*Lanikai
Revetment*

COASTAL ENGINEERING EVALUATION
AND ENVIRONMENTAL ASSESSMENT
FOR RECONSTRUCTION OF SHORE PROTECTION
AT LANIKAI, OAHU, HAWAII
(TMK: 4-3-04: 78, 79, 88, 108)

SUPPLEMENT

**COASTAL ENGINEERING EVALUATION
AND ENVIRONMENTAL ASSESSMENT
FOR RECONSTRUCTION OF SHORE PROTECTION
AT LANIKAI, OAHU, HAWAII
(TMK: 4-3-04: 78, 79, 88, 108)**

FIGURE 4. ALTERNATIVE REVETMENT TYPICAL SECTIONS
 (Approx. Scale 1"=6')

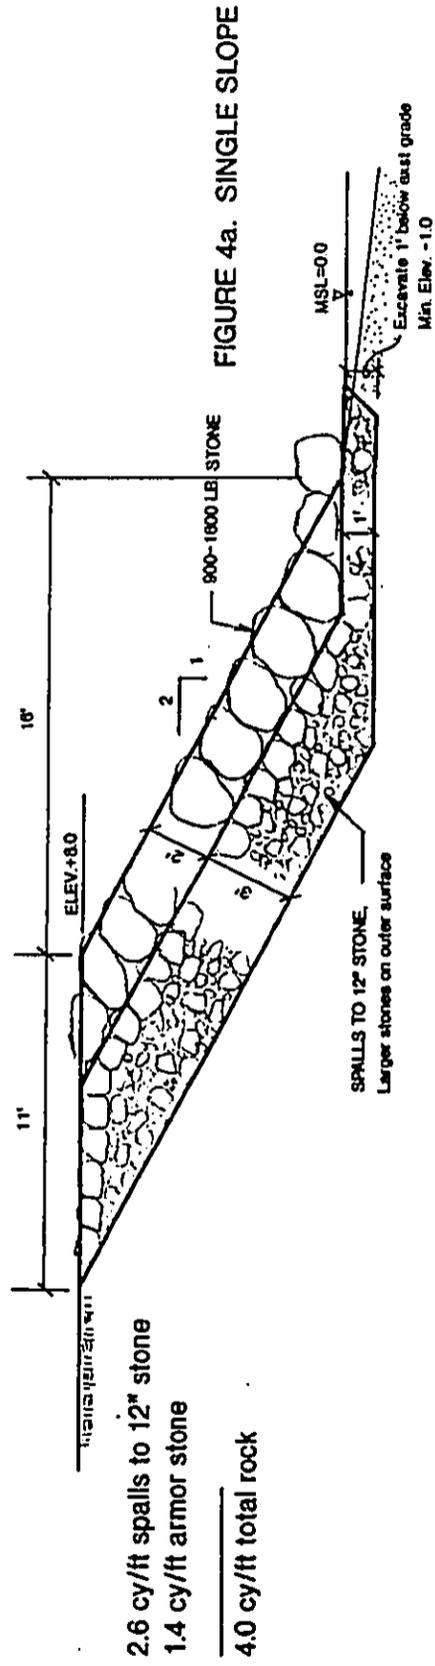
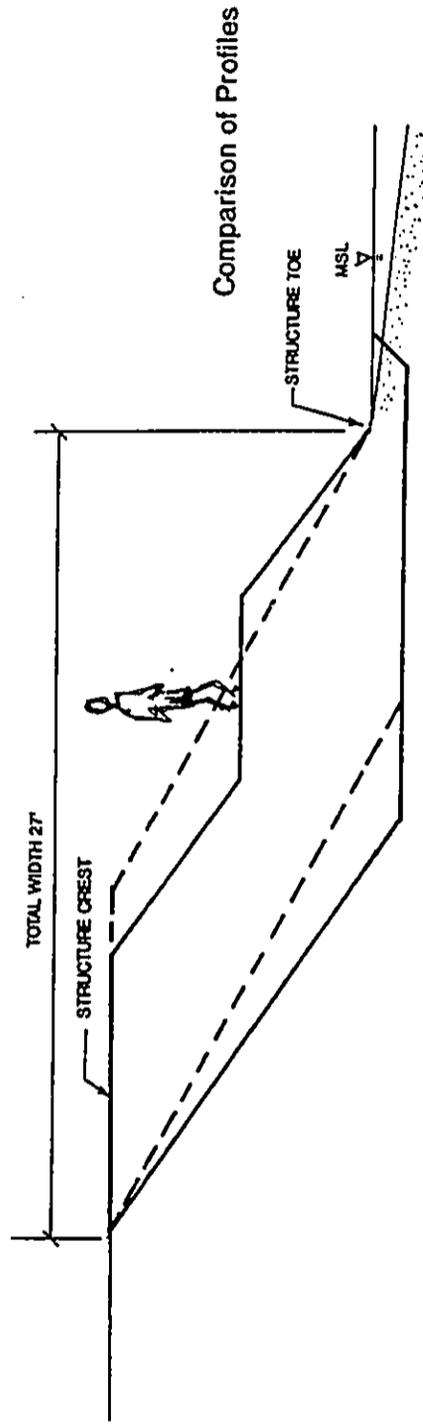
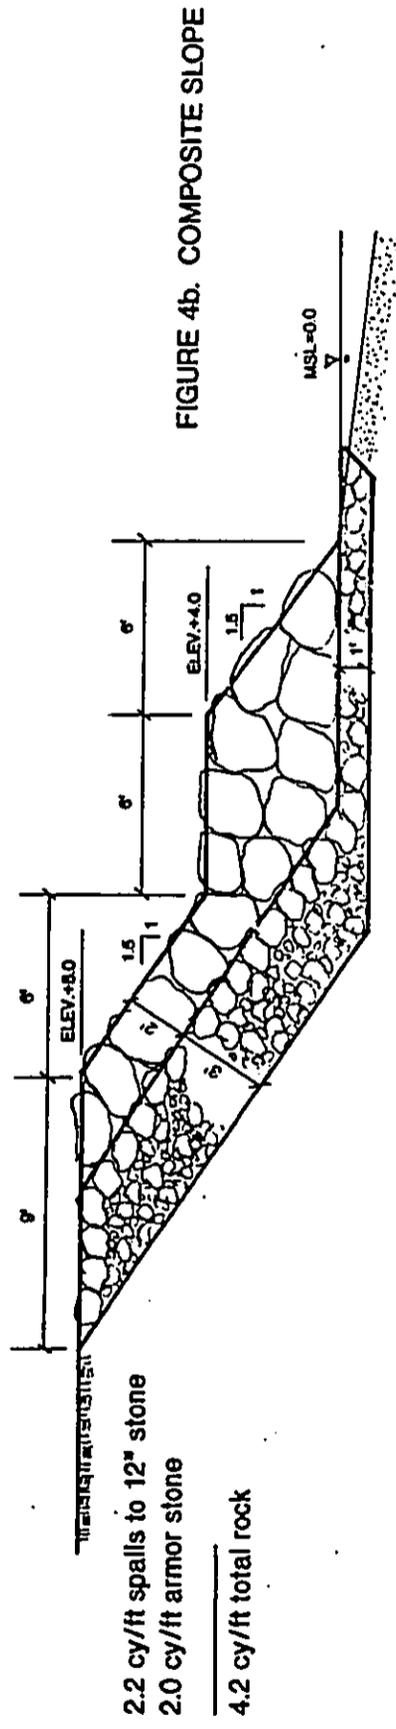
3. Comment: There is a concern that the 1-foot thick bedding layer beneath the extended toe may not be adequate, and it was recommended that additional toe protection be provided.

The proposed composite slope design of the wall is one of the better methods of constructing sea walls. Figure 4b, the composite slope, illustrates the construction design preferred by reviewers, and we recommend that the Department of Land Utilization require this design to be used if a permit is issued. We are not able to determine from the information provided whether or not a separator or filter cloth will be installed. If not, it is recommended that one be used beneath the rock revetment to keep the water from eroding the area under the wall. The extended toe of the revetment is to be underlain with a 1-foot thick bedding layer of spalls to 12-inch stone and placed -1.0'MSL. This may not be adequate. Additional toe protection for the seawall is recommended.

Response: The construction plan calls for a minimum 1-foot thick bedding layer excavated beneath existing grade, with a minimum excavated depth of -1.0' MSL. Because certain reaches will be situated seaward of the shoreline with existing grade below MSL elevation (estimated water depths about 1-2 feet below MSL at the toe), the depth of excavation at the toe could be 2-3 feet below MSL, which is below the anticipated scour depth for typical waves. Certain reaches that are situated landward of the shoreline with existing grade above MSL would require considerable excavation to place the bedding layer at -1.0' MSL. Because it is difficult to accomplish controlled excavation in sand below the water surface, a minimum amount of excavation is specified. As stated in the EA, the composite slope design increases the stability of the revetment slope under storm wave attack. The 6-foot wide armor stone bench dissipates wave downrush, reduces scouring, and provides a greater safety factor by allowing the armor stones in the bench to settle into any potential scour hole without damaging the integrity of the upper revetment slope. In essence, the 6-foot wide bench functions as an extended toe for the revetment slope. Therefore, toe protection for the revetment slope is considered adequate.

FIGURE 5. ALTERNATIVE LAYOUT PLAN FOR REVETMENT ENTIRELY LANDWARD OF SHORELINE

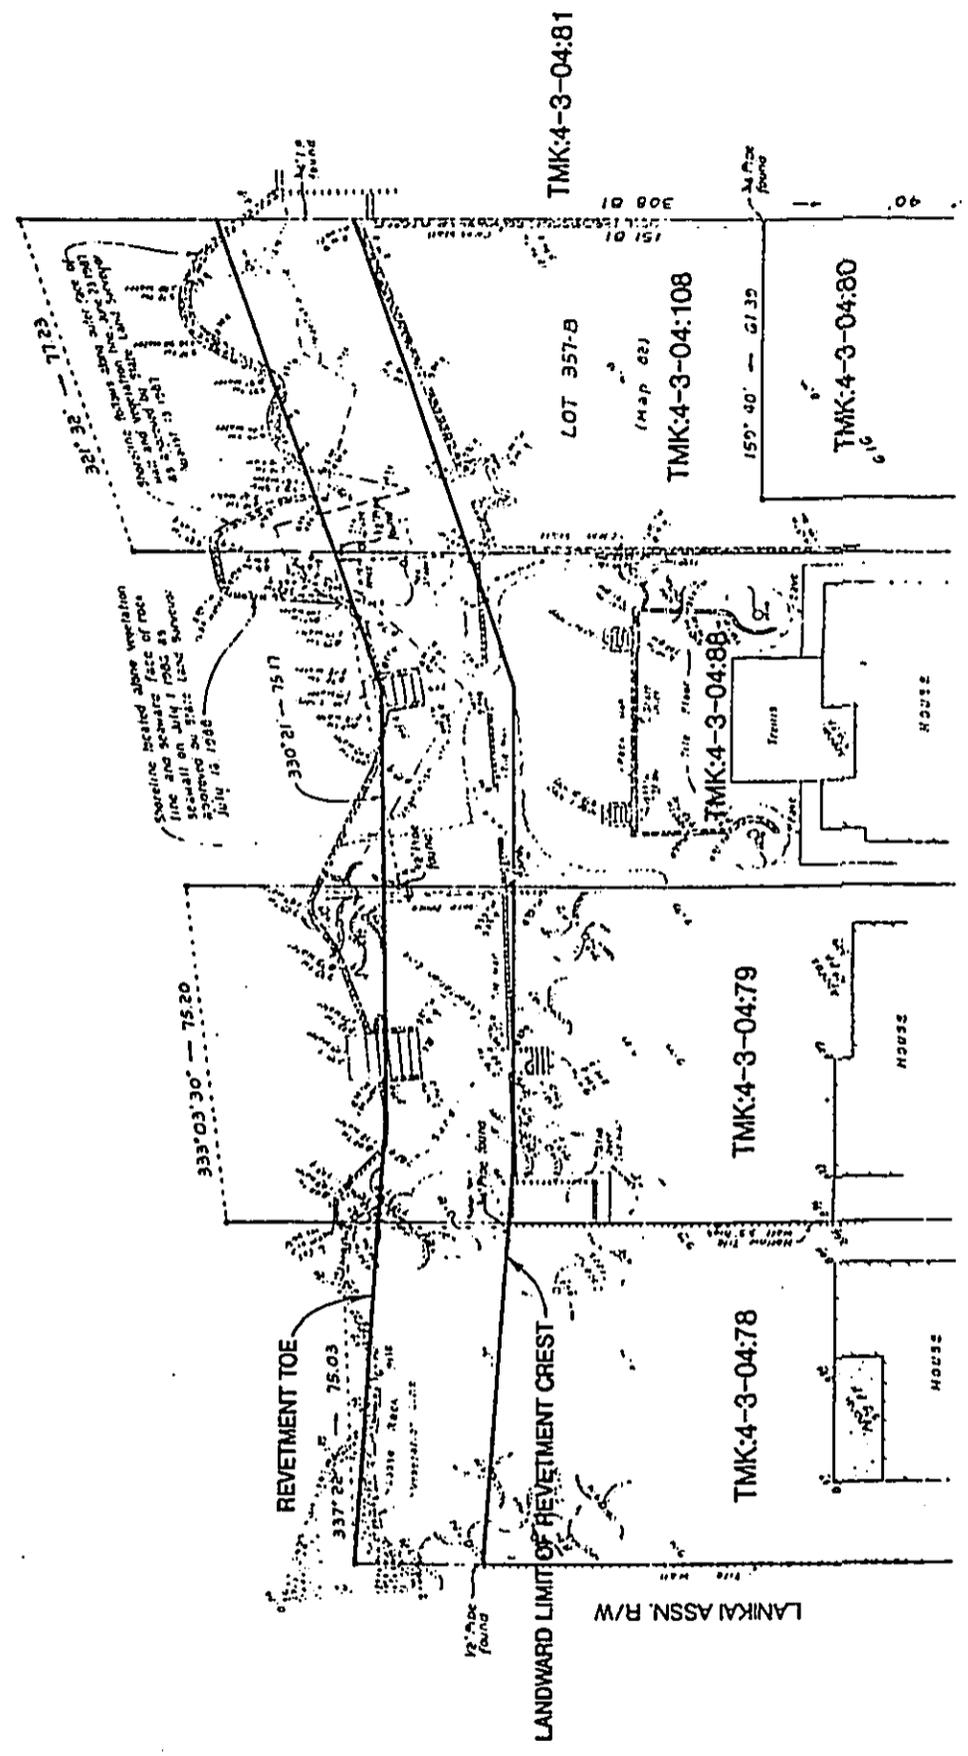
1. Comment: It was suggested that the revetment be constructed at a location between that shown on Figures 5 and 6 in the EA.

plan in figure 5 uses less public land than the layout in figure 6. It seems most appropriate that the seawall be constructed as much on private land as possible. Since mature trees exist on a portion of the figure 5 proposal, proving its historical existence as fastland, perhaps a location between that of figure 5 and the one in figure 6 would be equitable.

Exhibit 1 shows the revetment alignment copied from the construction plan. This revetment alignment is a compromise between the alignments shown on Figures 5 and 6 in the EA, whereby the revetment crest is situated entirely landward of the existing seawalls and shoreline along its full length. The proportion of State versus private land areas affected by the proposed revetment is as follows:

Response: The construction plan places the revetment alignment at a location between that shown on Figures 5 and 6 in the EA.

FIGURE 6. RECOMMENDED ALTERNATIVE LAYOUT PLAN FOR REVETMENT

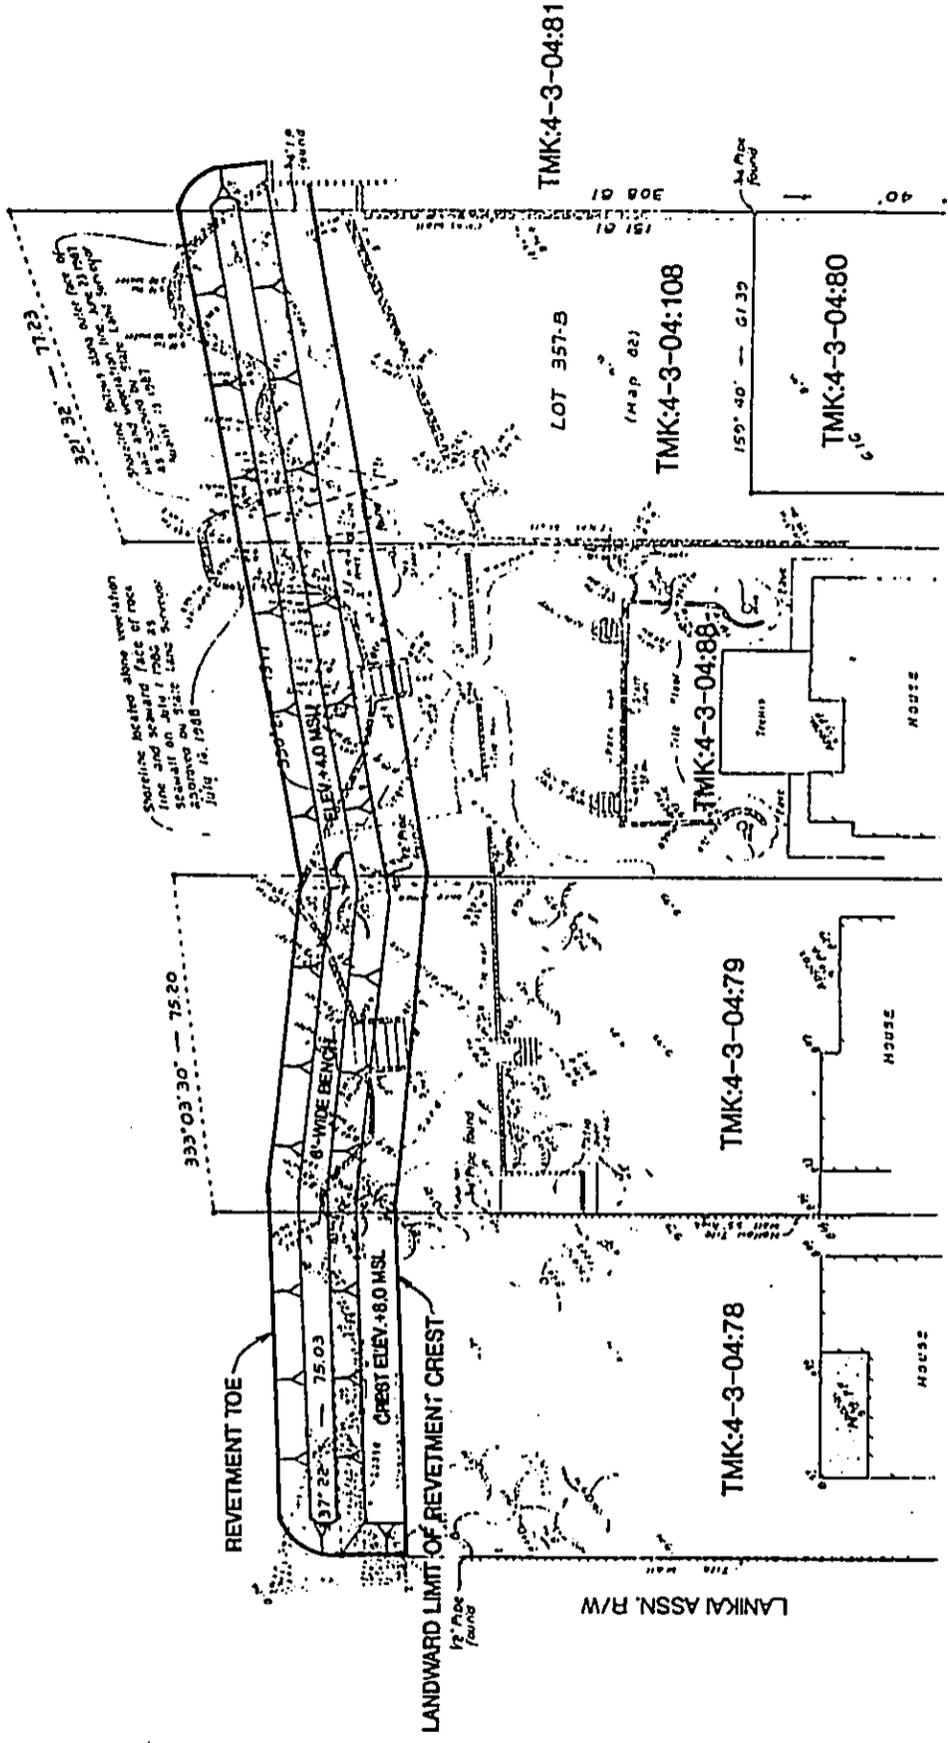
The preferred location for the seawall (figure 6) is on approximately half public land and half private land. The proposed alternative layout

OVERFLOW SWALE - NO. 2
PLAN
 SCALE: 1/8" = 1'-0"

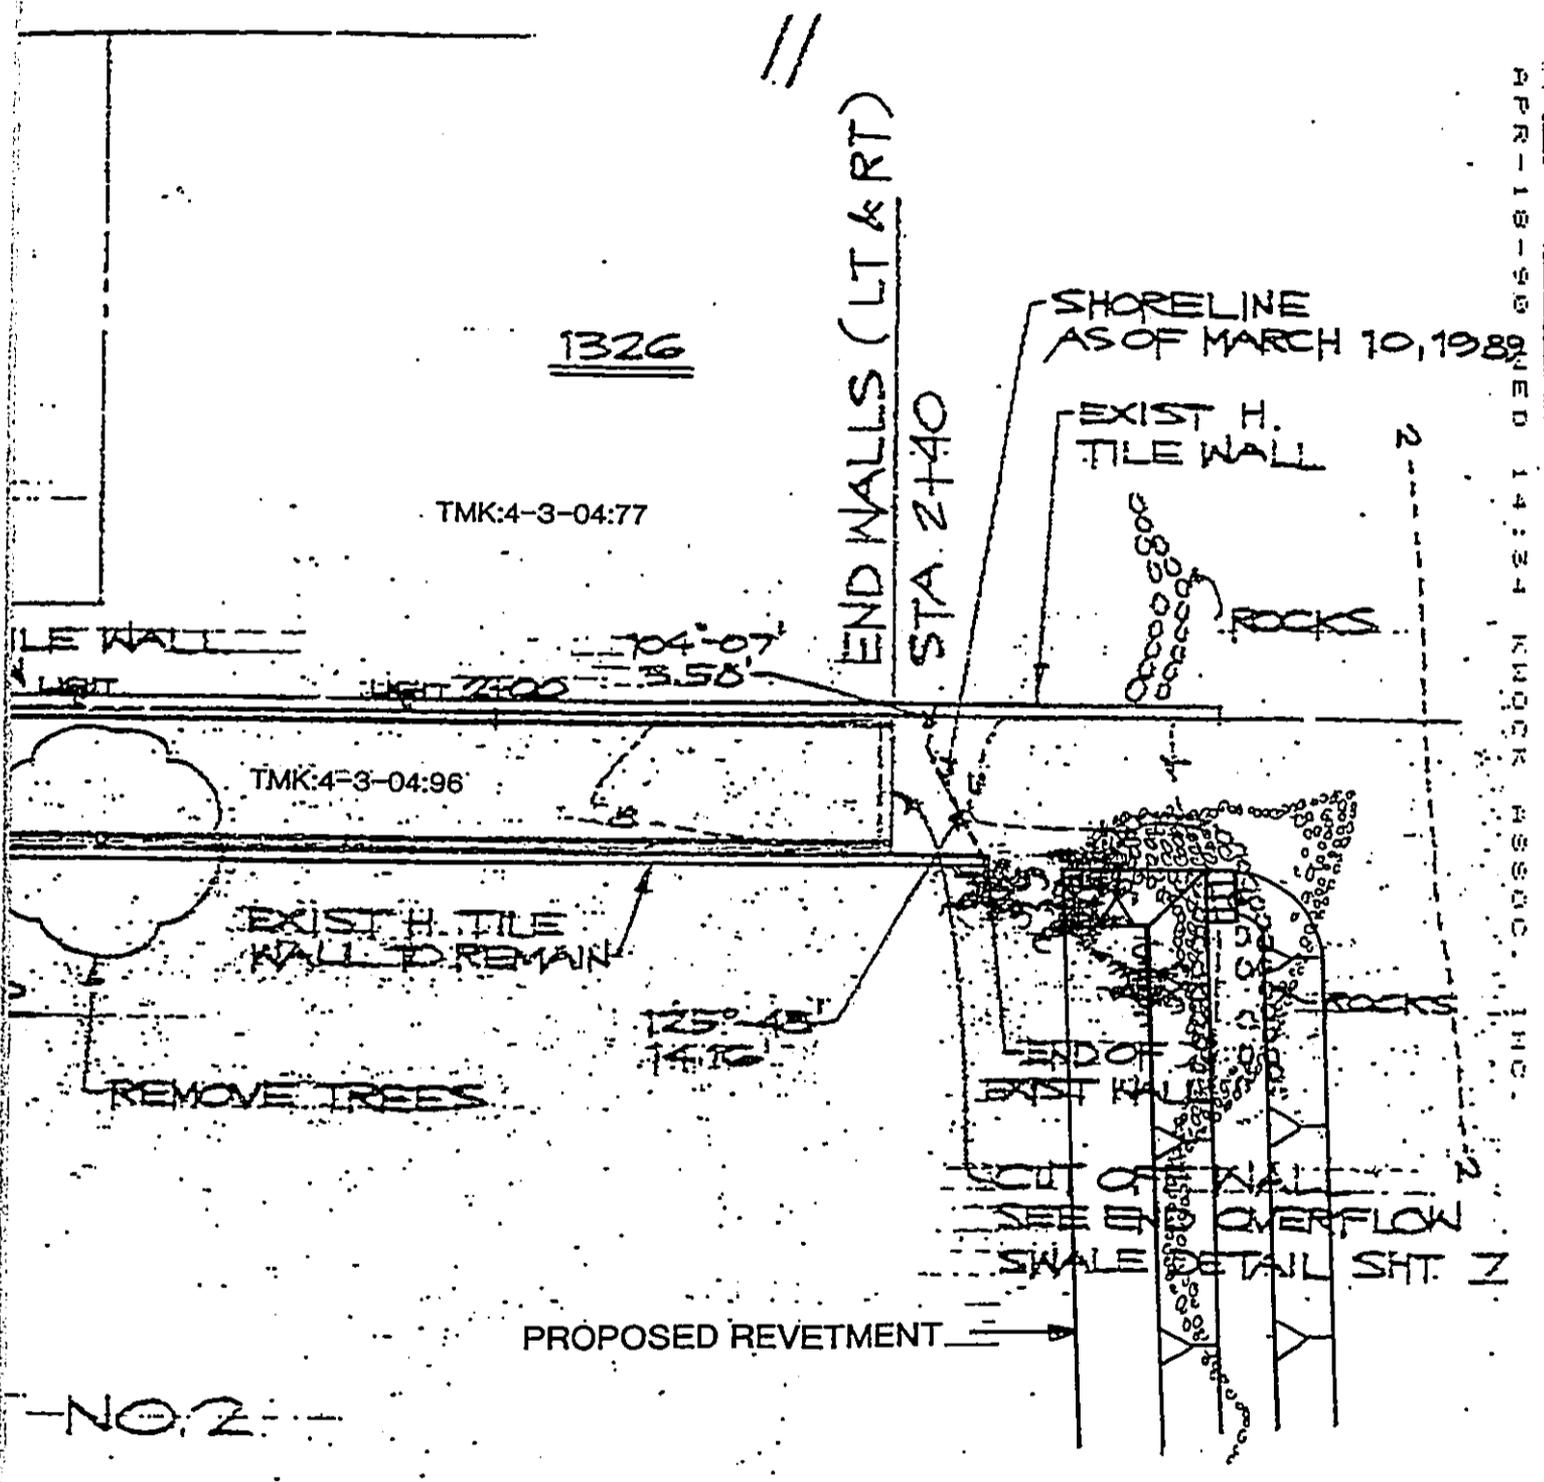
1. Comment: The C & C Department of Public Works (DPW) is planning to construct overflow swales through the beach right-of-ways along this Lanikai shoreline reach. They are concerned about possible impacts that the revetment may have on the construction of the overflow swale through the right-of-way next to Parcel 78.

1. Although the subject EA (page 14) states that the proposed revetment will not impact on the existing beach right-of-way adjacent to Parcel 78, we wish to point out that Department of Public Works is planning to construct overflow swales along the beach right-of-way as a part of the Lanikai Flood Control Project. We suggest that the EA should address whether the revetment will have any impact on the overflow swales.
2. Is there bedrock in the area? Can the proposed revetment toe be extended to the bedrock?

Response: This matter was coordinated with Mr. Ken Kwock of Kwock Associates, the engineering consultant to the C & C DPW for the design of the overflow swales. It was concurred that the proposed revetment will have no adverse impact on the proposed construction of the overflow swale. The present design for the overflow swale consists of constructing containment walls along the boundaries of the right-of-way to channel the runoff through the right-of-way. The overflow swale stops at Sta. 2+40, and does not extend as far seaward as the existing CMU wall along the northern boundary of Parcel 78. Exhibit 2 shows a portion of the plan for the overflow swale, prepared by Kwock Associates, on which the proposed revetment has been drawn in. Because the overflow swale stops short of the revetment location, and the revetment does not intrude into the right-of-way, the projects can be constructed independently of each other and neither project will have an impact on the other.
